Saddleback Ridge Wind, LLC // Natural Resource Protection Act
(NRPA) and Site Location of Development Act applications

- Licensee Exhibit 5
Memorandum from RSG to Andy Novey
(February 23, 2011)

To:	Andy Novey
From:	Kenneth Kaliski, INCE Bd. Cert. Emily Eros, INCE
Subject:	RSG Rebuttal -- Petition for a Public Hearing, Saddleback Ridge Wind Project
Date:	23 February 2011

Figure 1: Monitored vs modeled sound levels for a receiver 2,000 feet downwind of a 67-turbine wind farm using a ground absorption factor of 0 and a 2 dB confidence interval on the sound power levels

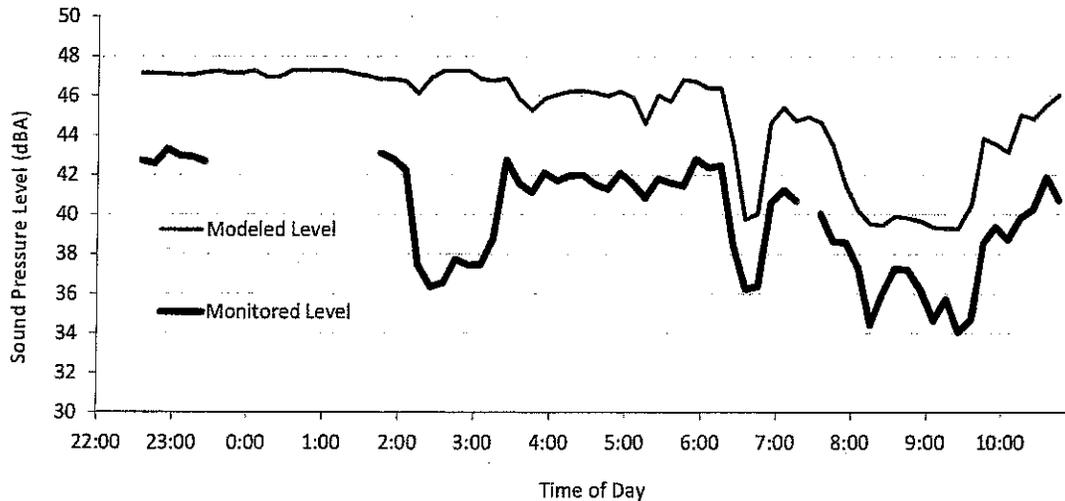
FMM questions the accuracy of the Cadna/A software and ISO 9613-2 methodology, particularly in modeling ridge-mounted turbines. FMM states that RSG should have included a 3 dB tolerance associated with errors in applying the ISO-9613-2 methodology and offers an alternative formula for predicting sound levels.

We calibrated this model on actual data from an operating wind farm and published our results.¹ The chart below shows the monitored sound levels at 2,000 feet from the closest turbine and the modeled sound levels using the same parameters used in the Saddleback project. On average, the modeled level is 4.8 dB higher than the monitored level. Clearly the model we are using to estimate sound levels for this wind farm has a conservative bias, which

means the noise levels will have been overestimated in comparison to actual levels, as demonstrated in Figure 1.

Figure 2: 2009 Measured and 2011 Modeled Leq Sound Pressure Levels (dBA) at Stetson Wind

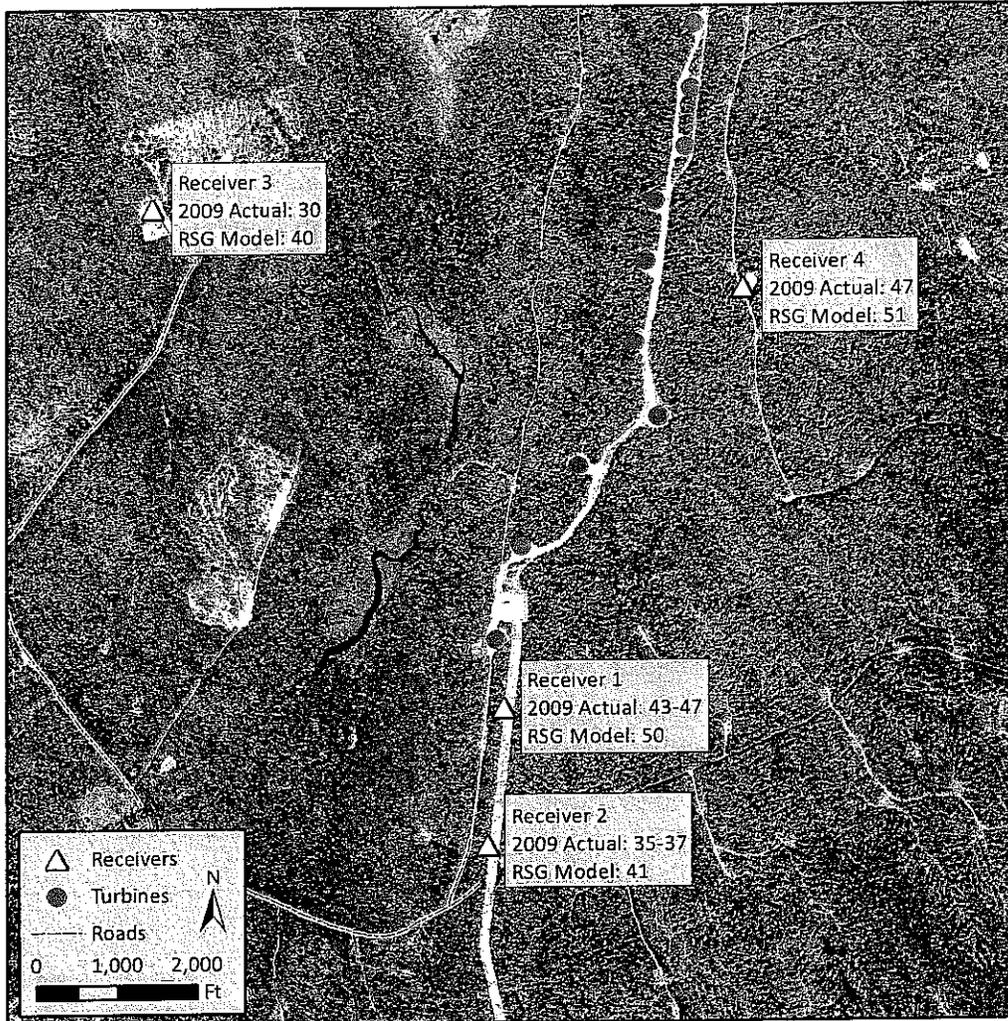
Mr. James states that Cadna/A and RSG's methodology should not be used to model noise sources located on a ridgeline. To investigate this question, RSG performed a calibration study for Stetson Wind, New England's largest utility-scale wind farm, located along a ridgeline in Washington County, Maine. RSG modeled Stetson Wind using the same parameters as Saddleback Ridge: $G=0$, spectral ground attenuation, and a +2 dB confidence interval. We

We then compared RSE's monitoring results to modeled sound levels using $G=0$ and a +2 dB correction for the as-built wind farm. Results are presented in Figure 2.

Figure 2 shows that actual monitored sound levels are at least 3 dB below RSG's modeled levels. As winds were blowing from the west and southwest during the monitoring period, Receiver 4 was directly downwind of the turbine string and is therefore the best test site in the scenario. At this location, the monitored sound levels are 4 dB below RSG's modeled levels. As a result, this calibration clearly shows that the modeling parameters used for Saddleback Wind are conservative estimates of worst-case sound levels, regardless of topography.

Figure 3: Difference between line source and point source model results, calculated as line source minus point source grid. Red colors indicate higher and green colors indicate lower levels in the line source model compared with the point source models.

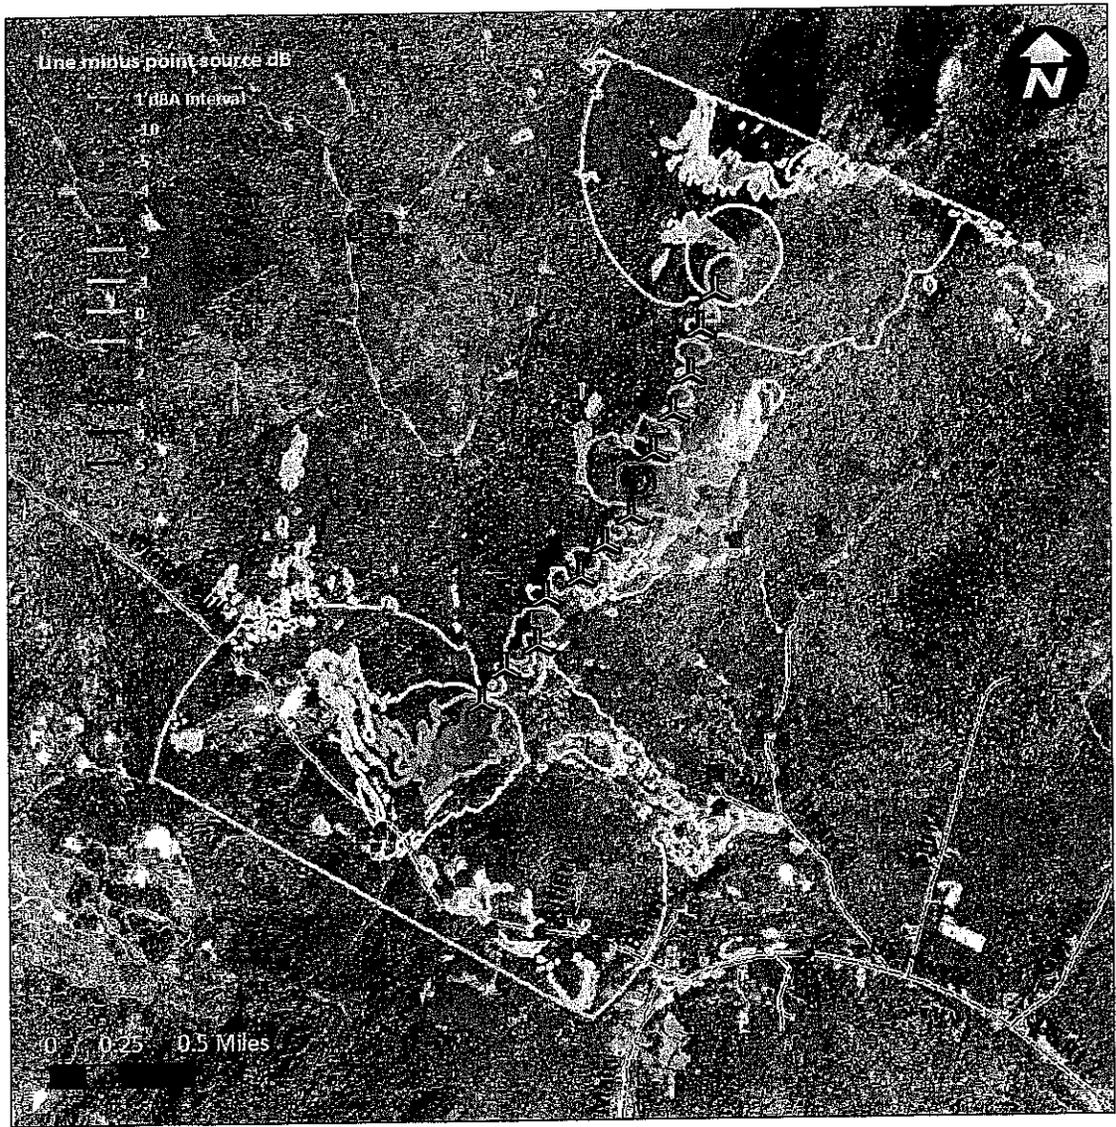
FMM Exhibit 2 offers an alternative formula for modeling a wind turbine string as a line source rather than as a point source. Mr. James' modeled levels are higher than RSG's modeled levels.

Figure 3 shows the difference between the line source and point source results. The line source results are lower to the north and south of the project because the sound power from the northern- and southern-most turbines is distributed along the line rather than concentrated in points (turbines) at both ends of the project layout. At homes to the east and southeast, there is essentially no difference between the point and line source model results. The line source results are higher in between the turbines. This is expected, as the line source method models sound emissions in places where there are no point sources (i.e. in between turbines).

While both models give roughly equivalent results perpendicular to the turbine string, we believe the line source model does not accurately represent impacts along the turbine string axis. As a result, the point source model, as used in the Saddleback Ridge Wind application, represents the better approach to modeling sound propagation from the wind farm.
